HISTORIC AND DESIGN REVIEW COMMISSION

HDRC CASE NO: 2018-190
ADDRESS: 1910 E HOUSTON ST
430 N MONUMENTAL
129 FLORENCE ALLEY
LEGAL DESCRIPTION: NCB 1372 BLK 4 LOT 1&2
NCB 1372 BLK 4 LOT 3 & N 20 FT OF 4
NCB 1372 BLK 4 LOT E 75 OF S 20 OF 4, E 75 OF 5 OR 4B & 5B
ZONING: C-2, RM-4 H
CITY COUNCIL DIST.: 2
DISTRICT: Dignowity Hill Historic District
APPLICANT: L. Shannon O'Malley
OWNER: L. Shannon O'Malley
TYPE OF WORK: Construction of four, two story, single family residential structures
APPLICATION RECEIVED: April 13, 2018
60-DAY REVIEW: June 12, 2018
REQUEST:

The applicant is requesting conceptual approval to construct four, two story, single-family residential structures on the vacant lots bounded by N Monumental, E Houston and Florence Alley. The lots included in this request are numbered 40, 41, 47 and 48.

Lot - 47

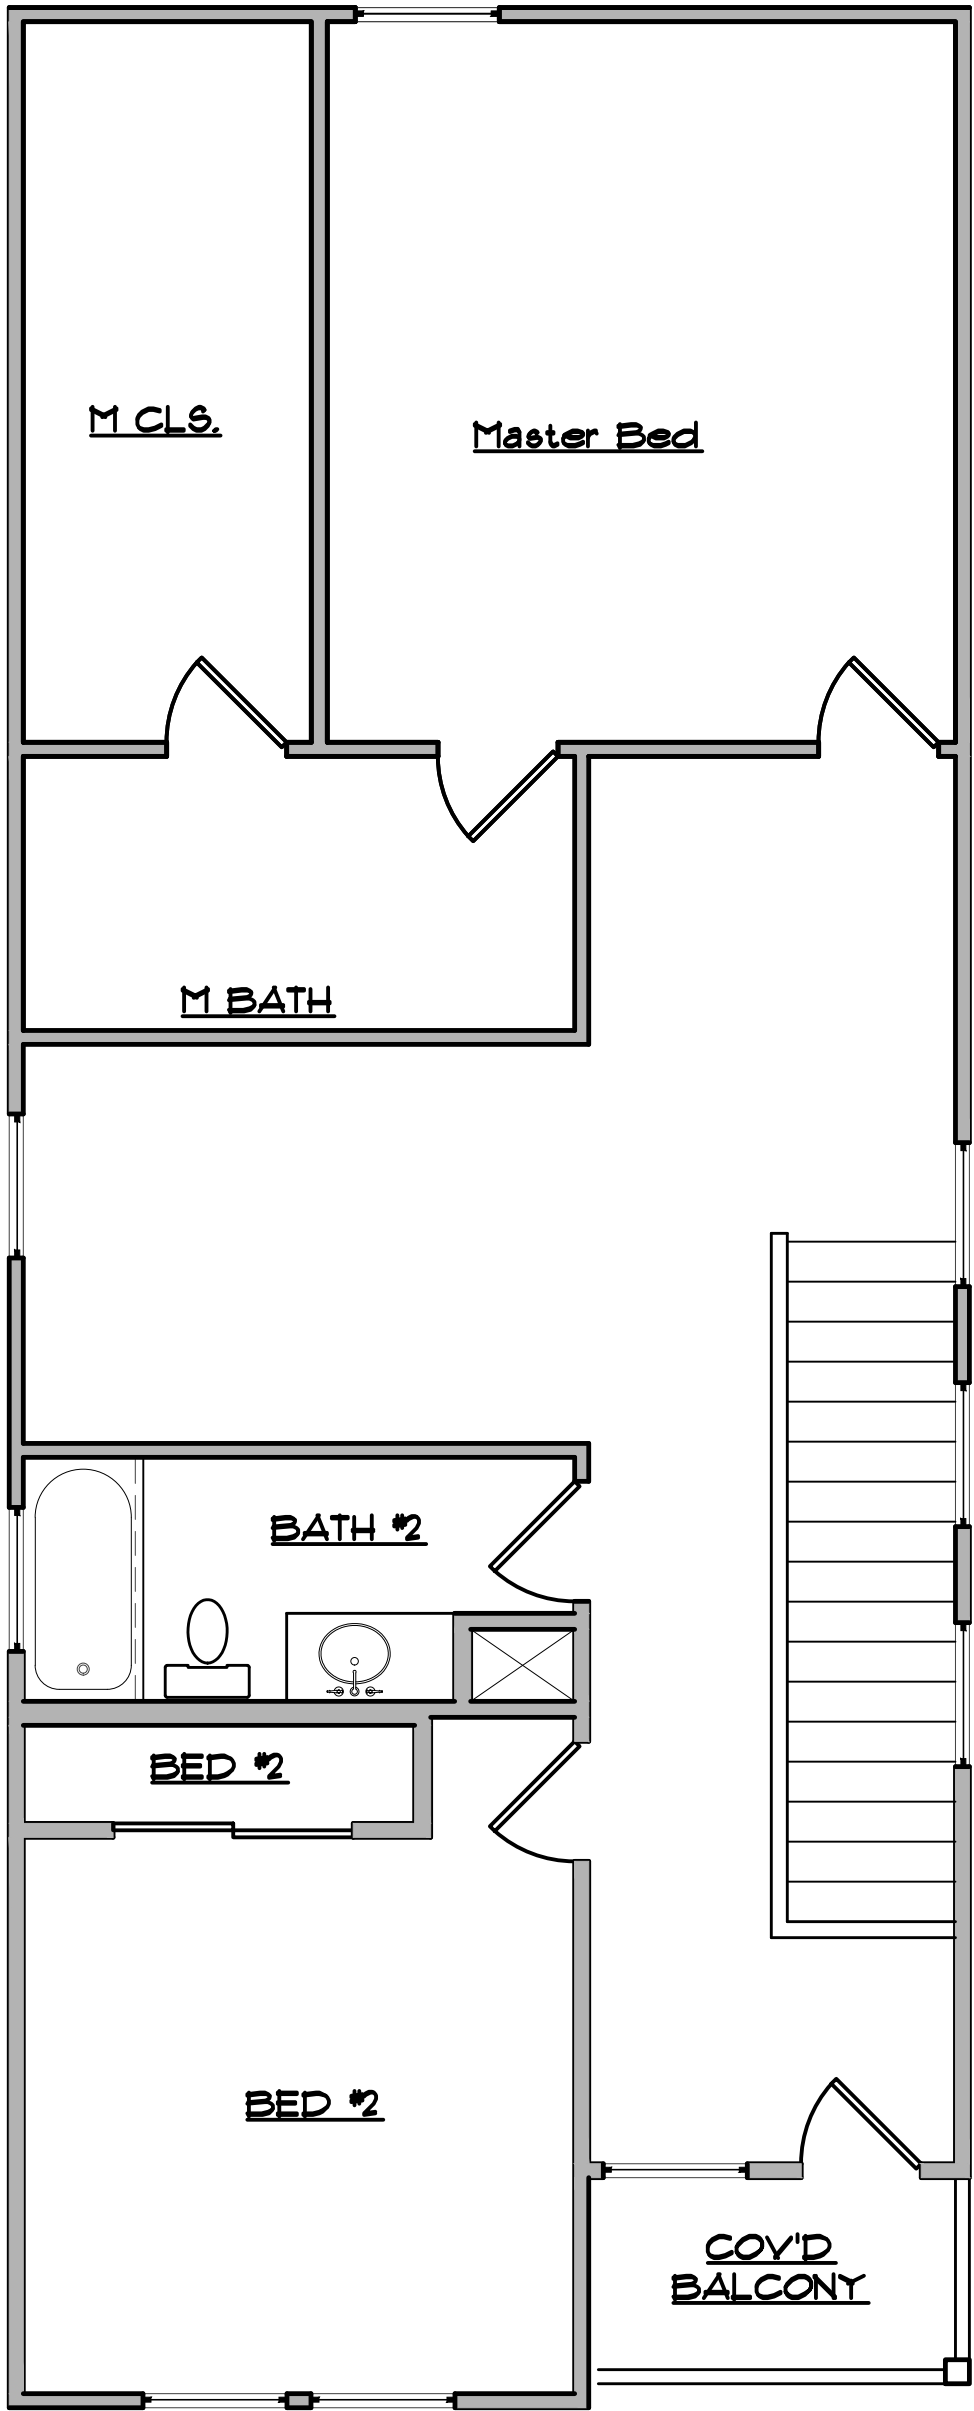
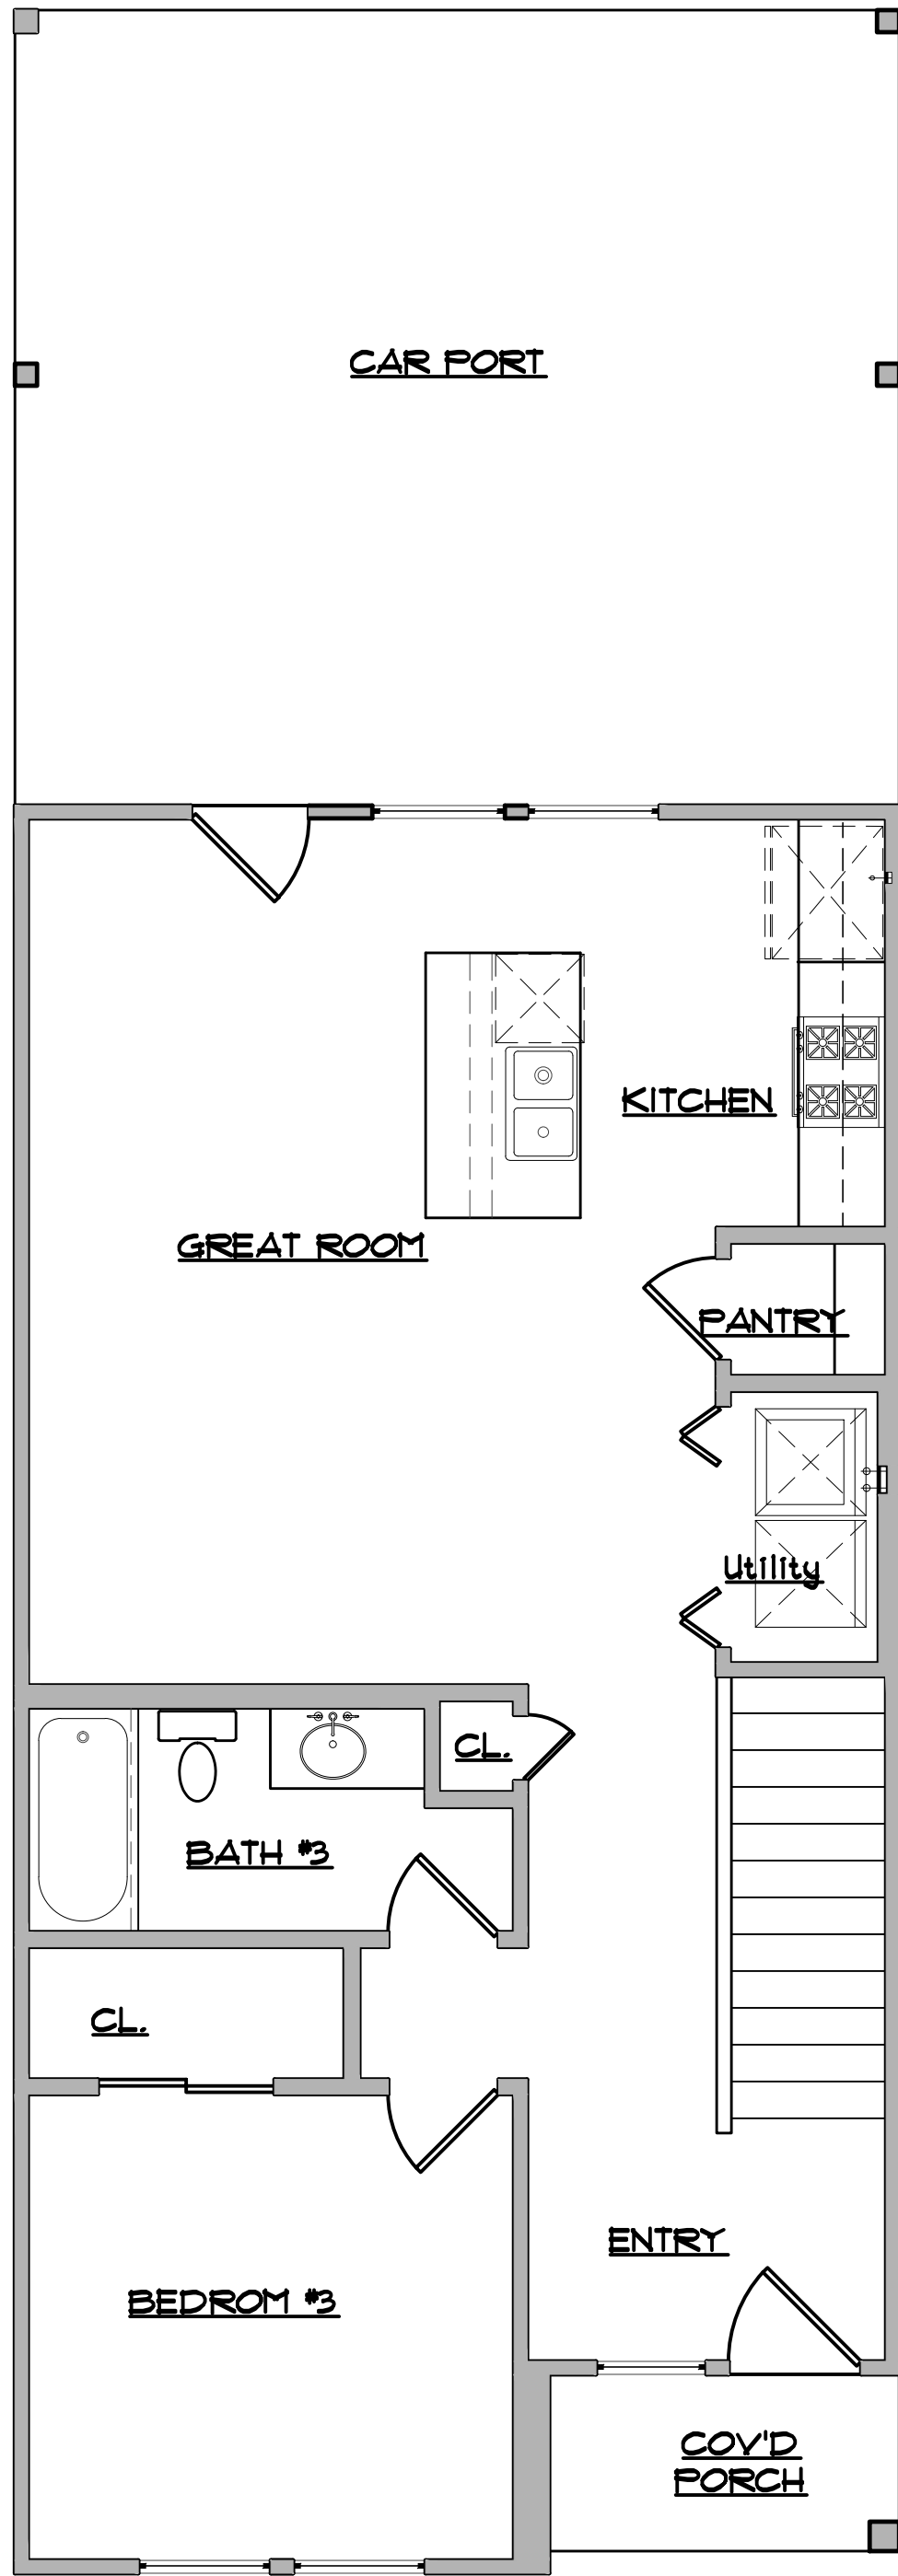
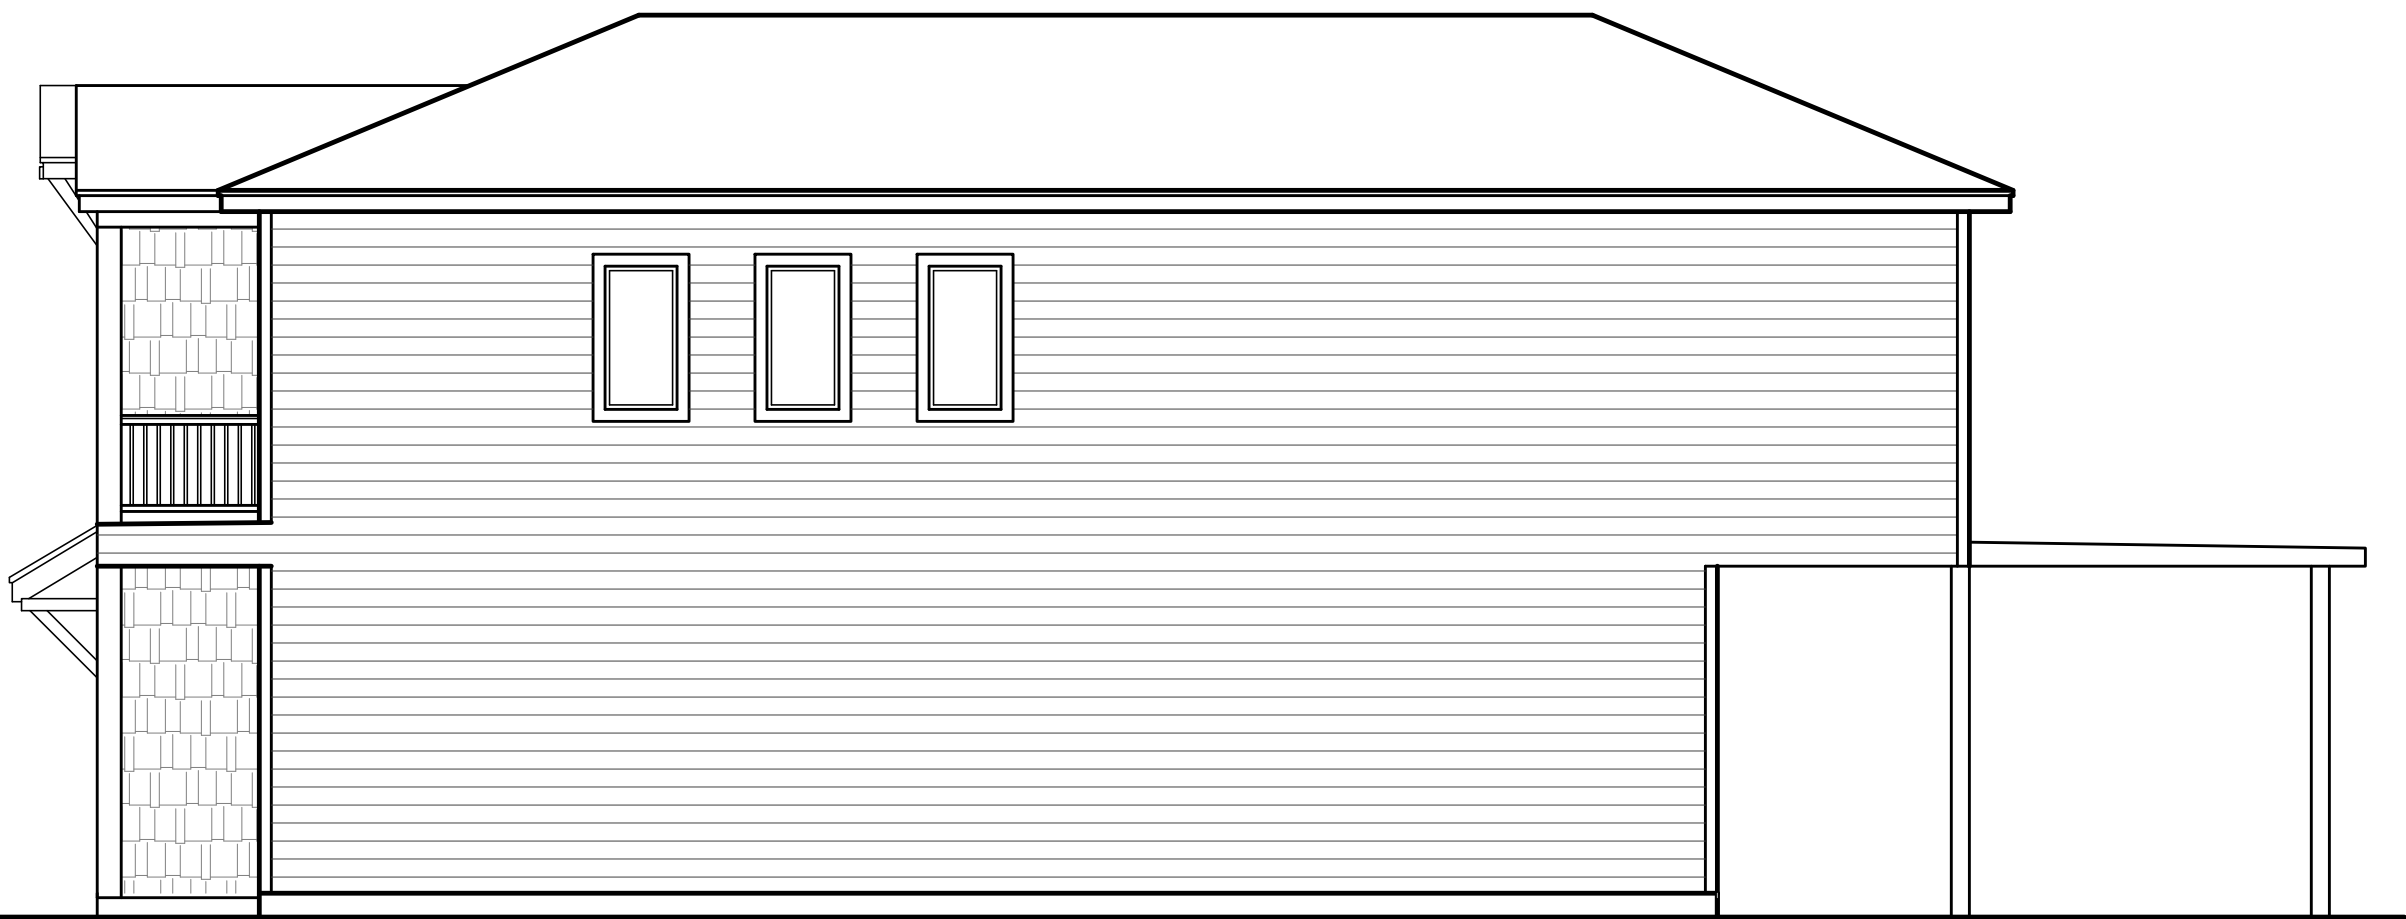
- o. **ARCHITECTURAL DETAILS**– The proposed new construction on lot 48 should feature a transom window above the proposed front door, sash windows and windows or doors at the terminus of the proposed wrap around porch. The proposed new construction on lot 47 should feature a smaller window adjacent to the front door, or a centered door with side lites and a transom window. All transom windows should feature divided lites.

- vii. That the proposed new construction on lot 48 feature a transom window above the proposed front door and a window or door on both levels one and two where the wraparound porch terminates. The proposed new construction on lot 47 should feature a smaller window adjacent to the front door, or a centered door with side lites and a transom window. All transom windows should feature divided lites.
